**UN Regulation No. 129 (Enhanced Child Restraint Systems)**

## **Proposal for draft Supplement 7 to the 02 series of amendments to Regulation No. 129 (Enhanced Child Restraint Systems)**

### **Submitted by the expert from Spain\***

Figure 3  
Minimum distance for lateral impact

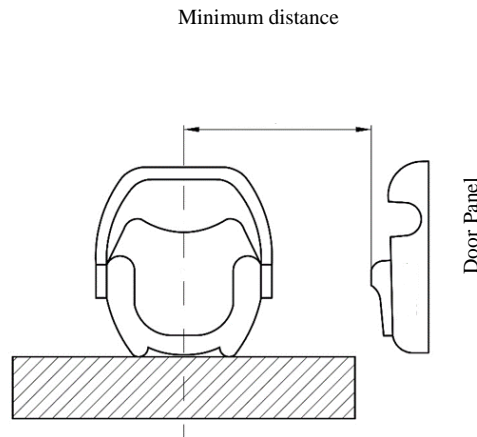
**For each test, the initial position of the side impact door panel relative to the bench shall be adjusted according to the minimum distance between the vehicle's door panel and the centre of the seating position as shown in figure 3.**
